**COMMITTEE OF THE WHOLE (PUBLIC MEETING) – MARCH 5, 2024**

**Re: Committee of the Whole (Public Meeting) – Written Submission**  
**Public Meeting Date: March 5, 2024 at 7:00 PM**  
**Agenda Item #3.1 and Name: 171 Maplecrete LP and 1930328 Ontario Inc.**  
**City File #: CIHA.23.003**

**General Location: Northeast Corner of Maplecrete Road and Doughton Road, VMC**  
**Property Description: 171 Maplecrete Road, 140 and 160 Doughton Road, and**  
**Block 2 on Registered Plan 65M-4793**

**Comments on Westerly Neighbour's CIHA Application (171 Maplecrete LP and 1930328 Ontario Inc.) ("the Liberty CIHA Application")**

## Composite Site Plan

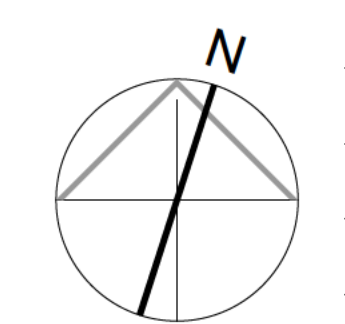
3. The westerly neighbour's building placements along their east property line proposes a 3-metre podium setback and a 5-metre tower setback, which is insufficient when there are three towers with heights of 24, 29 and 29-storeys and a 6-storey podium straddling the entire mutual property line. We are concerned their proposed development does not currently take into consideration our client's filed applications nor does it provide for the possibility to accommodate 50% of the potential north-south road being sought by Staff through the VMC Secondary Plan review.

4. In consideration of our client's applications, we question the likelihood that the westerly neighbour can meet the required 25-metre tower separation distance from our client's future towers given the closeness of their buildings along the mutual property line. Each developer must place their towers a minimum of 12.5 metres from their respective property lines to ensure

that there will be a minimum 25 metres total distance separation of towers between adjacent properties (as provided for by our client's applications). Liberty's proposed towers are setback 5 metres from their east property line which should be setback an additional 7.5 metres to achieve a setback of 12.5 metres. This minimum setback would also provide for the opportunity to accommodate the potential north-south road between the two proposed developments.

5. Our client's site plan shows a 2.94-metre road widening on the south side of their property to facilitate half (13 metres to centreline) of the total 26 metre Doughton Road right-of-way. It appears that the Liberty proposed development is only providing a 2.44 metre road widening, which is insufficient to create the full Doughton Road right-of-way. The VMC transportation staff will need to review this matter further to resolve the discrepancy.
